**ROYAL COMMISSION OF INQUIRY INTO BUILDING FAILURE CAUSED
BY CANTERBURY EARTHQUAKES**

CTV BUILDING COLLAPSE

**STATEMENT OF EVIDENCE OF R. GRANT WILKINSON IN RELATION TO CTV BUILDING
DATE OF HEARING: COMMENCING 25 JUNE 2012**

**OFFICE BUILDING
249 MADRAS STREET**

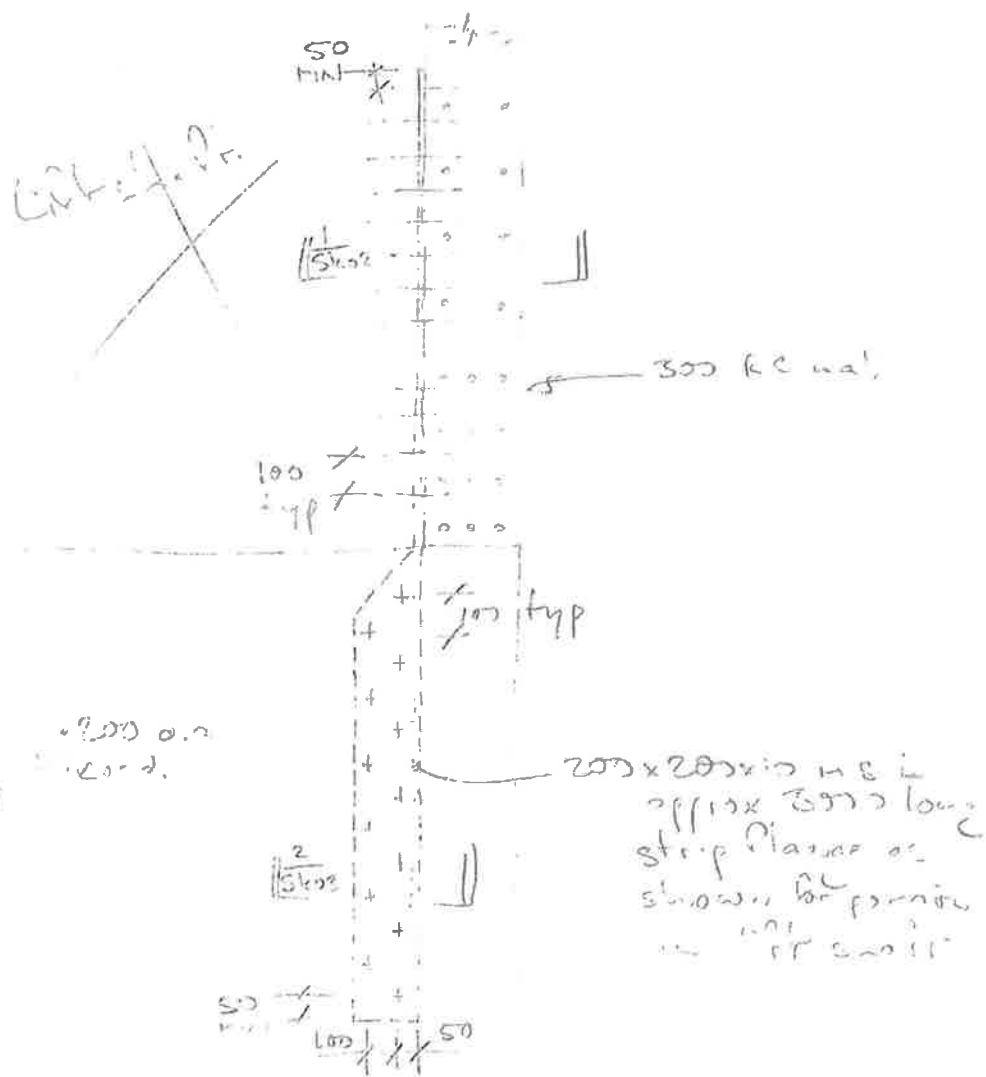
- 15 John Hare did some calculations and sketches for remedial ties for the purpose of establishing a budget cost for remediation work so that the client could have a rough estimate of the cost of that work. Mr Hare's sketch allowed for the insertion of a steel connecting angle to both of the affected walls at levels 2 to 6 in the building, a total of 10 angle ties. Mr Hare's sketches were not intended to be for construction. **BUI.MAD249.005 .19/20/21.**
